### **QANTAS Group Flight Training Centre** **Peer Review of TUFLOW Model**

## **Attachment A: TUFLOW Model Review Outcomes**

## QANTAS FLIGHT TRAINING FACILITY TUFLOW MODEL REVIEW

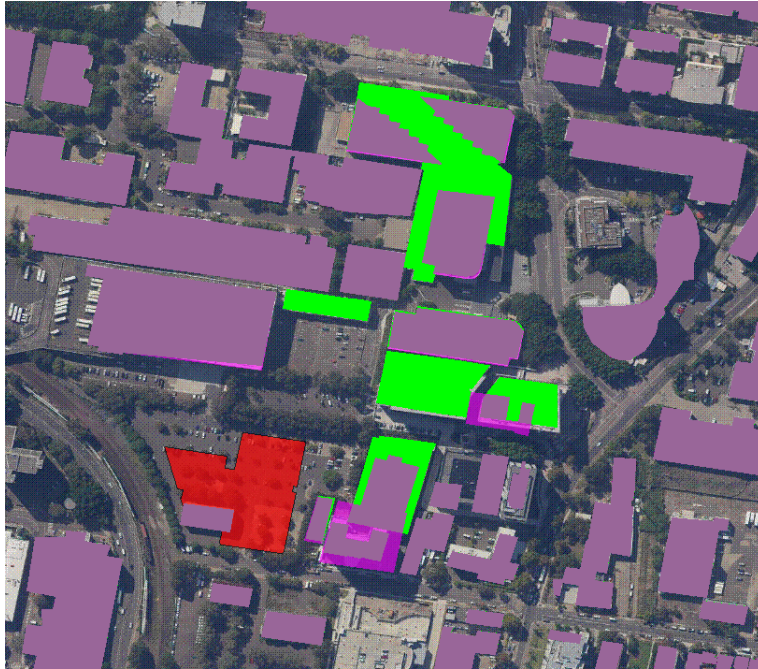
ITEM	REQUIREMENTS / CRITERIA	COMMENTS	REQUIRED UPDATES	ACTION
		 <p> The post development scenario includes a proposed terrain DEM (190716-proposed.asc), and a zshp (2d_zsh_en_north_olf_L , 2d_zsh_en_north_olf_P) to enforce an overland flowpath on the site that allows water movement along the northern and western extents of the proposed carpark (extent of proposed DEM shown below, and overland flowpath z shape shown as a red line) </p>
